**MINUTES
TOWN OF AMHERST
DESIGN ADVISORY BOARD MEETING
September 28, 2023
6:00 PM**

- 1.1. DESIGN REVIEW FOR SITE PLAN, SP-2023-06, FOR A MIXED-USE DEVELOPMENT AT 1720, 1740 & 1760 MAPLE ROAD
Property Located at 1720, 1740, & 1760 Maple Road
PB Investors, LLC., Petitioner

Re: Updated Project Submission
DAB Application for 1760 Maple Road [SP-2023-06]
Applicant: PB Investors LLC c/o Paul Bliss

DRAWING NAME:
Site Plan

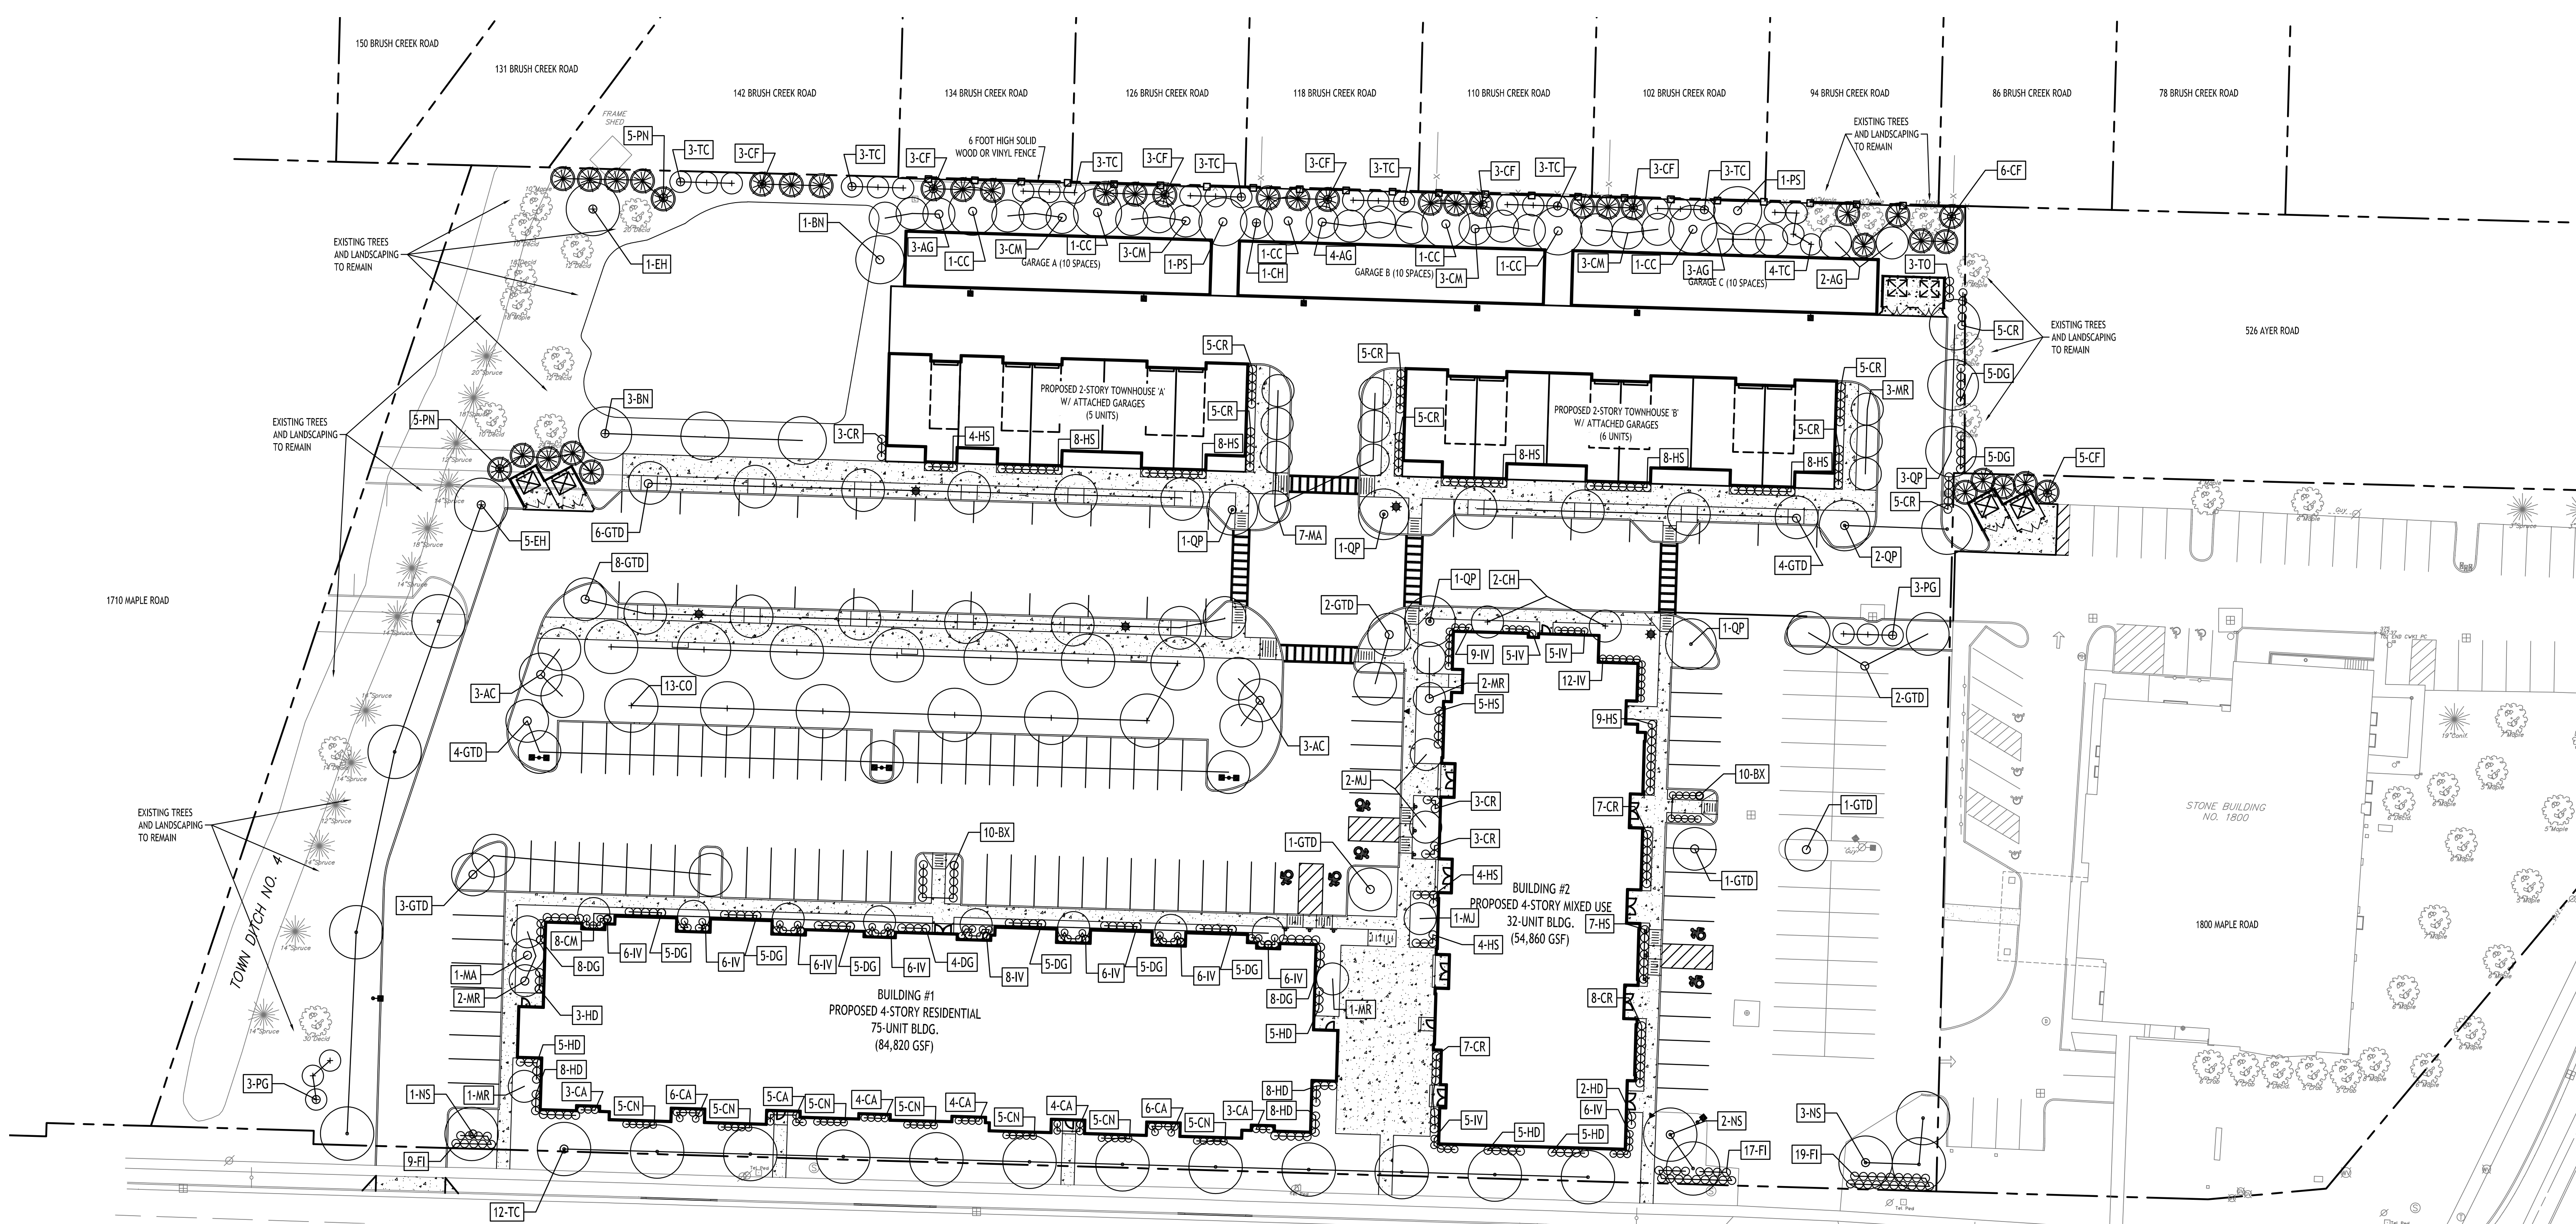
1. That final site plan identify furnishings for outdoor amenity spaces.
2. That final site plan include bicycle rack(s) on the east side of the mixed-use building.
3. That final plan indicate proposed locations and nature of public art.
4. That the final site plan be revised to replace the proposed white vinyl fence with a high quality wood fence.
5. That the final site plan include streetscape amenities along the proposed local street.

DRAWING NAME:
Landscape Plan

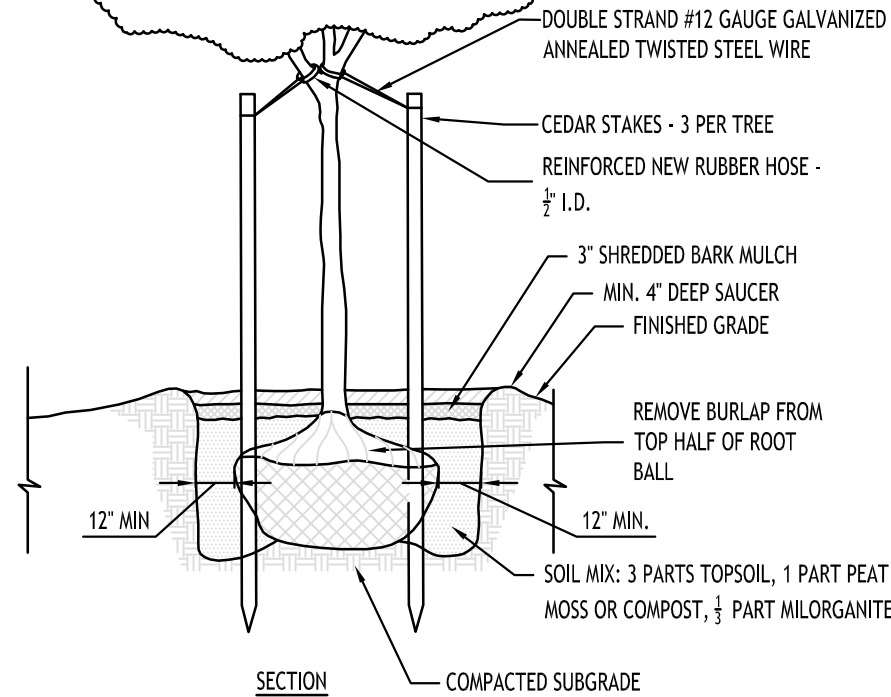
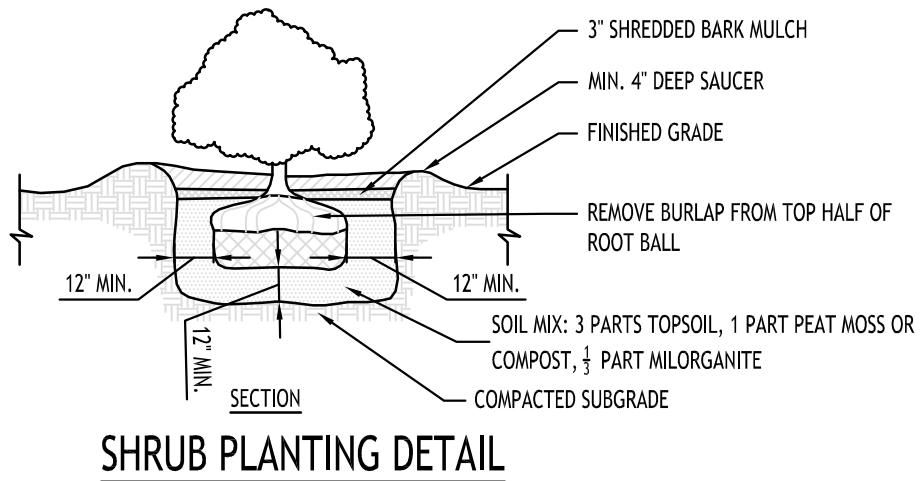
B-5a. *The building design is rather formulaic and predictable. If the intent of this guideline is to create visual interest at street level adjacent to the public realm, the building alone leaves lots of opportunity for improvement. The landscaping may be a useful way to help create some visual interest, especially some that helps define entrances. A simple change at a few key points from crabapple trees to something that “anchors” or “landmarks” the entrances will help create a visual cue for pedestrian access points.*

Response: Differences in materials and opening heights at the retail portion of the mixed-use building to be located along Maple Road should direct interest to those areas of the public realm, with a landscaped courtyard between the two building types are meant to further signify this distinction. Landscaping related comments will be addressed in connection with an updated Site Plan submission. During a meeting that Patrick Sheedy, P.E. and Sean Hopkins, Esq. attended with Daniel Howard, Daniel Ulatowski and Scott Marshall of the Planning Department on Friday, September 15th, the Planning Department requested that crabapple trees be replaced with another tree type and this input will be provided to Robert Walter, the project Landscape Architect.
